**PLANNED UNIT DEVELOPMENT &
SUBDIVISION STAFF REPORT****Date: December 17, 2009**

<u>NAME</u>	UNO Subdivision, Phase Two
<u>SUBDIVISION NAME</u>	UNO Subdivision, Phase Two
<u>LOCATION</u>	2889 Sollie Road (East side of Sollie Road, 245'± South of Shadow Creek Drive).
<u>CITY COUNCIL DISTRICT</u>	District 6
<u>PRESENT ZONING</u>	R-2, Two-Family Residential District & R-3, Multi-Family Residential District
<u>AREA OF PROPERTY</u>	17 Lots/10.3± Acres
<u>CONTEMPLATED USE</u>	Planned Unit Development Approval to amend a previously approved Planned Unit Development to allow the construction of a single-family residential development, and Subdivision approval to create 17-lots from a metes and bounds parcel.
<u>TIME SCHEDULE FOR DEVELOPMENT</u>	<i>Phase One:</i> Subdivision (UNO Subdivision, Phase One and Planned Unit Development approval has been granted by the Planning Commission for the Apartment Complex and permits for construction for Phase One have been issued to the general contractor. <i>Phase Two:</i> Subdivision (UNO Subdivision, Phase Two and Planned Unit Development) pending Planning Commission approval.

APPLICATION NUMBER 24 & 25 DATE December 17, 2009

SITE PLAN

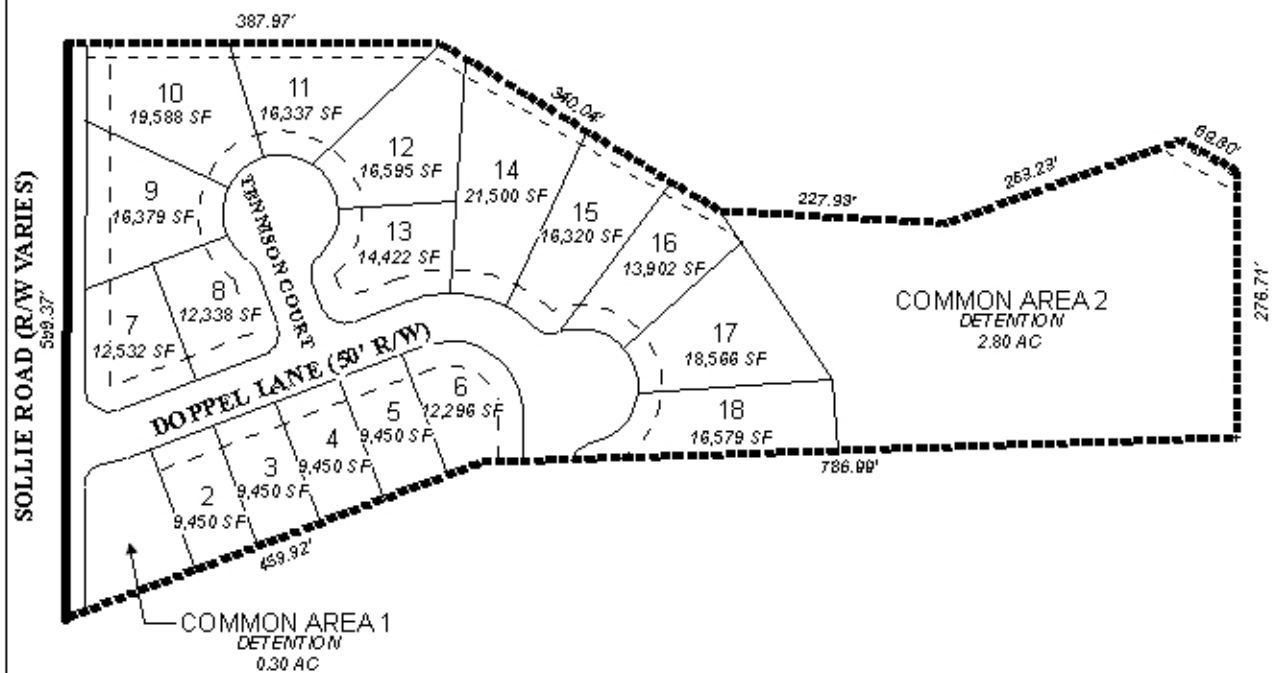
zoning would allow 40% maximum site coverage, but 45% has been allowed in similar cases as innovative subdivisions. As on the preliminary plat, the final plat should have a note stating the reduced side yard setbacks, except only for the interior lot lines on corner Lots 6, 7, 8, and 13, and 45% maximum allowable site coverage. It should be noted that while the subdivision is proposed to provide 5' side yard setbacks, any air conditioning unit over 3' in height will be required to meet the setbacks.

As illustrated on the preliminary plat, the site contains wetlands, which indicates that the area may be environmentally sensitive; therefore, the approval of all applicable federal, state and local agencies would be required prior to the issuance of any permits or land disturbance activities.

Detention/retention or common areas are depicted on the preliminary plat; therefore, a note should be placed on the Final Plat stating maintenance of these areas will be the responsibility of the property owners.

- 1) the dedication of sufficient right-of-way along Sollie Road to provide 50' from the centerline of Sollie Road;
- 2) placement of a note on the site plan and Final Plat stating that direct access to Sollie Road is denied for lots 7, 9, 10 and common areas;
- 3) placement of a note on the Final Plat stating that each lot (and common area if required for maintenance purposes) should be limited to one curb-cut each, with the size, design and location to be approved by Traffic Engineering and comply with AASHTO standards;
- 4) full compliance with the Traffic Engineering comments and the placement of a note on the Final Plat stating (*The connection shown between the single family units and the apartment complex is to be an emergency access only and should be gated, as defined by the Traffic Impact Study*).

- 5) placement of a note on the site plan and Final Plat limiting corner lots 6, 8 and 13 to one curb cut each, with the size, design and location to be approved by Traffic Engineering and comply with AASHTO standards;

- 6) placement of a note on the Final Plat stating the reduced 5' side yard setbacks, except only for the interior lot lines on corner Lots 6, 7, 8, and 13, and the maximum allowable site coverage of 45% for all lots;

- 7) placement of a note on the Final Plat stating that maintenance of the common areas is the responsibility of the property owners;
- 8) labeling of all lots with size in square feet, or provision of a table with the lot size information on the Final Plat;
